Service Bulletin

Subject: Engine Oil Consumption on Aluminum Block/Iron Block Engines with Active Fuel Management (AFM)
(Install AFM Oil Deflector and Clean Carbon from Cylinder and/or Install Updated Valve Cover)

Models: 2007-2011 Cadillac Escalade Models
2007-2011 Chevrolet Avalanche, Silverado 1500, Suburban, Tahoe
2010-2011 Chevrolet Camaro
2007-2011 GMC Sierra 1500, Sierra Denali, Yukon Models
2008-2009 Pontiac G8 GT
Built Prior to February 1, 2011 (Updated Valve Cover) and October 2010 (AFM Shield)
Equipped with Any of the Following Engines:
– Aluminum Block V8 Engine with Active Fuel Management (AFM) (RPOs L94, LZ1, L99, LC9, LH6, L76, LFA, L92)
– Iron Block V8 Engine with Active Fuel Management (AFM) (RPOs LMG, LY5)
– Hybrid Engine (RPO LFA – Only Applies to Hybrid Models Built July 7, 2009 - February 1, 2011 – Prior Builds Not Cast For AFM Valve)

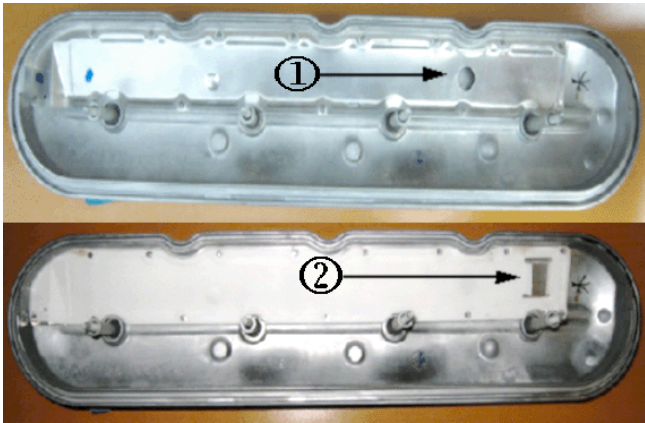
Aluminum or Cast Iron Block - Oil in Intake Manifold - Install Updated Valve Cover on All Models Built Prior to February 1, 2011

1) Old Design

2) New Design

PCV pullover or an overactive lifter can cause oil to be pulled through the PCV system even at low vehicle mileage. A correctly functioning PCV system will only leave a film of oil in the intake manifold. Inspect the intake manifold to see if there is any oil puddling in the bottom. If there is you will need to replace the left valve cover. Two new left rocker arm covers have been released for trucks and vans. Technicians should replace the left rocker arm cover with GM P/N 12570427 for 2007-2008 or GM P/N 12642655 for 2009-2011. Refer to the Parts Information below for the Camaro. This rocker arm cover has a relocated PCV drain hole that prevents oil from entering the intake manifold. Refer to Valve Rocker Arm Cover Replacement - Left Side in SI.

Note: These rocker covers are for specific years. The PCV orifice is different for each. The correct cover must be used or an SES light may set.

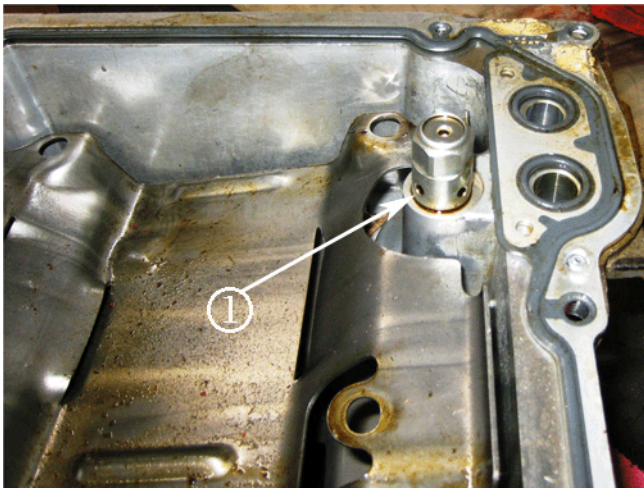
Aluminum Block - Oil Getting Past Piston Rings - Free Up Piston Rings and Install AFM Shield on All Non-Hybrid Models Built Prior to October 1, 2010 or all Hybrid Models Built July 7, 2009 - October 1, 2010

To correct this condition, install an AFM shield, perform the piston cleaning procedure as described in this document and install a new oil pan gasket per the procedure outlined in this document. Monitor oil consumption after this repair to ensure oil consumption has improved to acceptable levels.

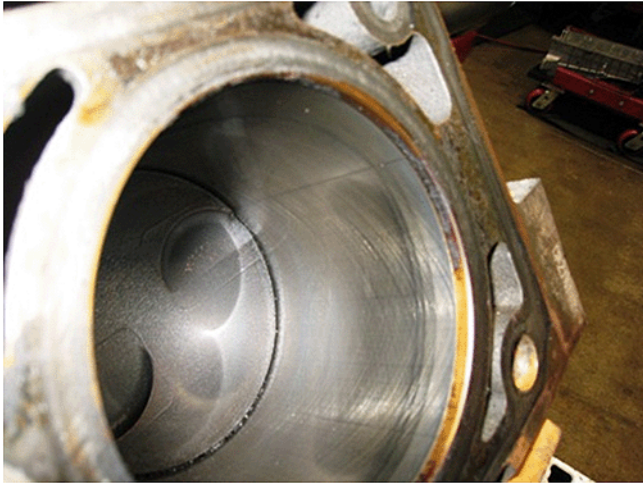
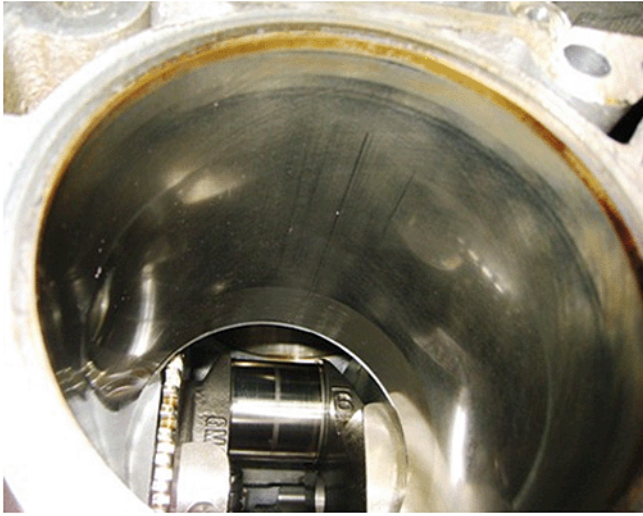
4. Remove the AFM valve (1).

5. Install the new shield (1), GM P/N 12639759, and tighten the AFM valve to the oil pan to 28 Y (20 lb ft).
